## INVITATION FOR BID (IFB) No. 021-005

### CONSTRUCTION OF ROLLING ROAD STATION IMPROVEMENTS

#### QUESTIONS AND ANSWERS

AS OF SEPTEMBER 1, 2020

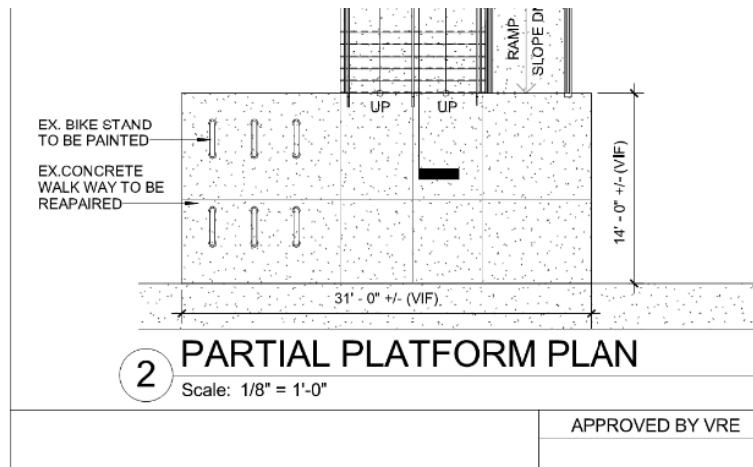
**Question #11:** Drawing number E-112 General Note 5 States "Contractor shall reuse existing conduit and conductors embedded in slab". Page Columns from E-9 to E-2 show dashed lines for conduit. Can you clarify if this is new conduit or existing to be reused?

**Response #11:** Keynote 5 in full states: "CONTRACTOR SHALL REUSE EXISTING CONDUIT AND CONDUCTORS EMBEDDED IN SLAB. CONTRACTOR SHALL REPLACE EXPOSED CONDUIT. CONTRACTOR SHALL PROVIDE NEW WIRING FOR ALL DEVICES, FIXTURES, AND EQUIPMENT."

Dashed lines between Columns E-9 and E-2 on Drawing E-112 indicate new conduit routed below grade noted by Keynotes 6, 8 and 20 on E-112.
